Access Compliance Report

Public Rights-of-Way

Intersection ID: 31878	Main Street: LANGDEN_GATE_DR	Cross Street: WILLIAMS_GLENN_RD	Location: SE
ADA ID: 5A49D45670D2	Ramp Type: BlendTrans1	Initial Pass/Fail: Pass	Overall Compliance: No
Severity Score: 2.75			
Codes/Mitigation Info/Possible Solution		Field Measurements/Component Compliance

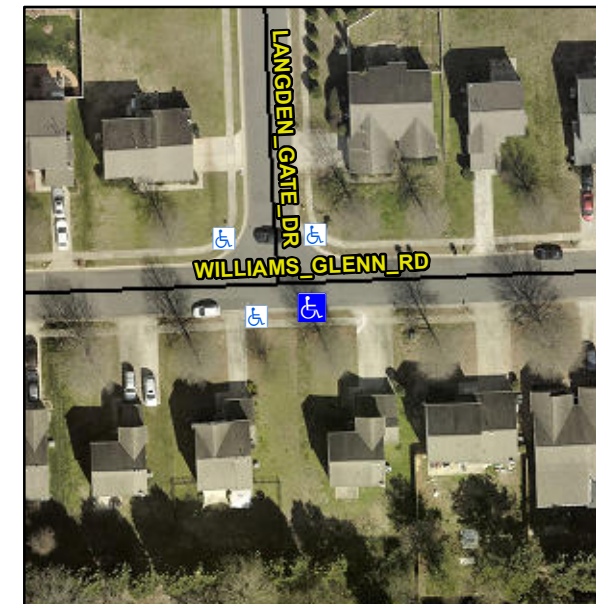
Not Found, R304.5.3, R304.2.2-Perp, R304.3.2-Para, R305.1.4, R305.2

Compliance	Description	Data	Compliance	Description	Data
N/A	Ramp Length (in)	46.0	Yes	BlendTrans Slope (%)	3.8
Yes	Ramp Width (in)	48.0	No	BlendTrans XSlope (%)	3.2
N/A	Flare Type LT	Sloped	N/A	Flare Type RT	Sloped
N/A	Flare Slope LT (%)	7.2	N/A	Flare Slope RT (%)	0.0
N/A	Flare Traversable LT?	No	N/A	Flare Traversable RT?	No
Yes	Landing Length (in)	48.0	Yes	DWS Provided?	Yes
Yes	Landing Width (in)	48.0	Yes	DWS Contrast?	Yes
No	Landing Slope (%)	4.0	Yes	DWS Length (in)	24.0
Yes	Landing X Slope (%)	2.6	No	DWS Full Width?	No
N/A	Landing Curb? (Y/N)	No	No	DWS Offset (in)	3.0
N/A	Shared Landing?	No			
Yes	Gutter Ponding?	No	Yes	Gutter Slope (%)	4.5
Yes	Gutter Lip Ht (in)	0.0	No	Gutter X Slope (%)	2.9
N/A	Painted X Walk1?	No	N/A	Painted X Walk2?	N/A
	X Walk 1 Direction	To N		X Walk 2 Direction	N/A
	X Walk 1 Width (in)	N/A		X Walk 2 Width (in)	N/A
	X Walk 1 Slope (%)	3.3		X Walk 2 Slope (%)	N/A
	X Walk 1 X Slope (%)	2.8		X Walk 2 X Slope (%)	N/A

N/A	Ramp inside XWalk1?	N/A	N/A	Ramp inside XWalk2?	N/A
	Road Slope (%)	2.8		Clear Space?	Yes
	Road X Slope (%)	3.3	N/A	Clear Space to XWalk (in)	N/A
Yes	Any Obstructions?	No	Yes	Storm Grate/Utility Hazard?	No
	Obstruction Type			Storm Grate/Utility Type	
		N/A			N/A
			Yes	Surface Condition? (G/P)	Good
			No	Curb Slope (%)	8.5

Remove & Replace Curb Ramp With Two New Directional Ramps or Equivalent. Remove & Replace Gutter.
